## Addendum No. 4

## CITY CENTER IN CLARKSTON STREETSCAPE PROJECT PI#0007613

**Date of Addendum Issuance**: July 27<sup>th</sup>, 2017

REVISION DATES		LVVID	SCADING		1 A N	ID DETAILS	
07/27/17			LAND	SCAPING	FLAIN		ID DETAILS
			CHECKED:	G. BOWMAN	DATE:	_	DRAWING No.
					DATE:	_	DITAWING NO.
			CORRECTED:	C. JUNG	DATE:	_	29-019
			VERIFIED:	G. BOWMAN	DATE:	_

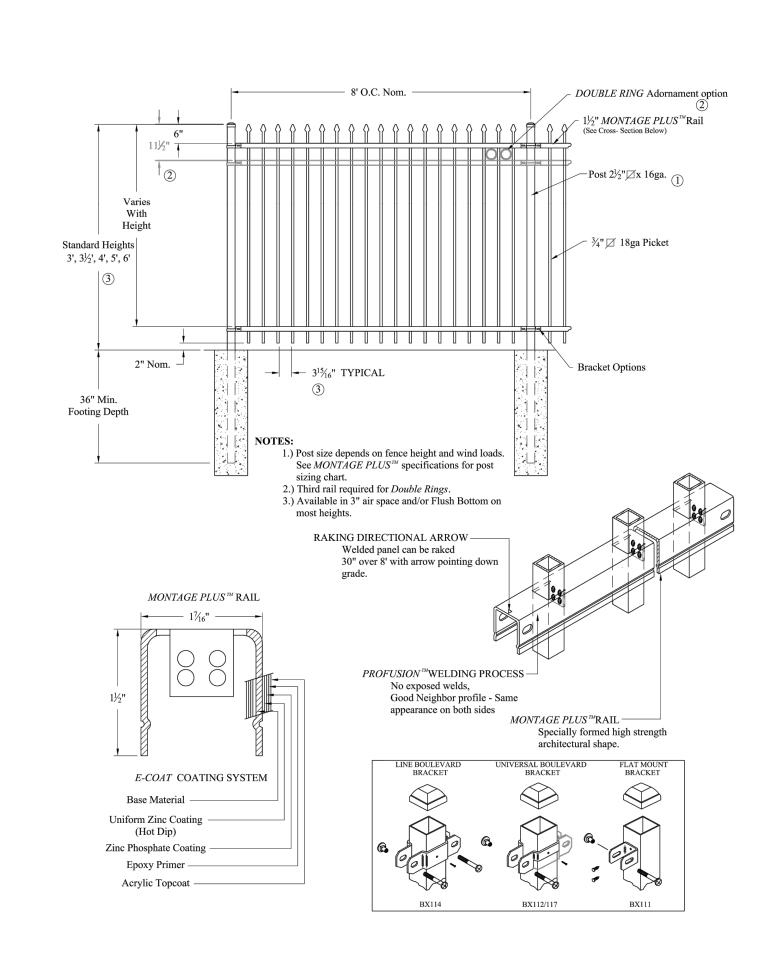
Question: The ornamental fence in the "summary of quantities" is called out as 6' high. The detail on sheet 29-019 calls it out as 48" height. Please Confirm"

Answer: The ornamental fence should be 6' high. Please refer to the corrected plan sheet #29-019 as attached

DECORATIVE FENCE						
MANUFACTURER	MODEL #	SIZE	FINISH	COLOR		
AMERISTAR	MONTAGE PLUS	72"	E-COAT™ PROTECTIVE	BLACK		
	CLASSIC		FINISH			
integrity	BELLA VISTA	72"	THE LifeCoat™	BLACK		
	PREMIER		POWDER COATING			
JERITH	BUCKINGHAM	72"	FencCoat® POWDER	BACK		
			COATING
